NUMBER: 03-003-02 REV. A

GROUP: Rear Axle

Rear Axle Whine Sound

This bulletin involves installation of a new rear propeller shaft with a damper on the front yoke.

Fig. 1 DAMPER LOCATION

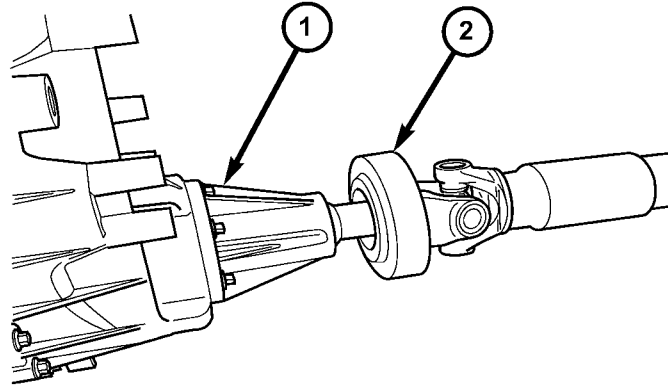
Follow the removal and installation procedures in Section 3 of the appropriate service manual for the model year under "Propeller Shaft - Rear". Refer to (Fig. 1) below for the location of the damper.

Qty.	Part No.	Description
AR	**52099485AF**	Propeller shaft (NV247 w/M35 Rear Axle)
AR	52111483AC	Propeller shaft (NV247 w/M44 Rear Axle)
AR	52105530AD	Propeller shaft (NV242 w/M35 Rear Axle)
AR	52105901AB	Propeller shaft (NV242 w/M44 Rear Axle)

NOTE: 52099485AF IS TO BE USED EXCLUSIVELY FOR THIS SERVICE BULLETIN (WITH NV247 w/M35 REAR AXLE). USE 52099485AE FOR ALL OTHER PROPELLER SHAFT REPAIRS NOT RELATED TO THIS BULLETIN (WITH NV247 w/M35 REAR AXLE).
